GENERAL SERVICES DR. 12" WATERLINE REPLACEMENT

PROJECT NO. 2020-076 BID NO. 2491

ADDENDUM 1

June 25, 2021

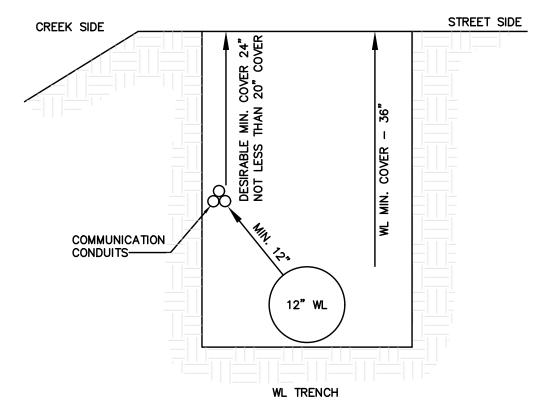
- 1. DRAWINGS:
 - Contractor shall install (3) 2" schedule 80 PVC conduits with handholes per conduit plan, included in this Addendum.
- 2. BID FORM:
 - Replace Bid Form in Exhibit A with the following:

Install three (3) nominal 2" PVC conduits, schedule 80. Conduits should either be uniquely colored or marked to allow easy identification.

Maintain 12" or more of spacing from the waterline. This spacing can be diagonal to the extent that the conduit is horizontally offset to the waterline. Maintain as much cover as possible over the conduits. There shall always be at least 20" of cover, 24" desirable.

For bends, use 45° elbows with a 36" minimum bend radius.

Install 24"x36"x36" Tier 22 handholes with split lids. Conduit shall enter a handhole through an opening in the handhole sidewall. There are 3 types of openings:

If making the openings in the field, observe the handhole manufacturer's instructions to maintain the handhole's Tier 22 load rating. Conduits shall be trimmed such that no less than 2" and no more than 4" protrudes into a handhole.

Install a ground rod in each handhole: 13-mil copper-clad steel, 5/8" diameter, 8' length.
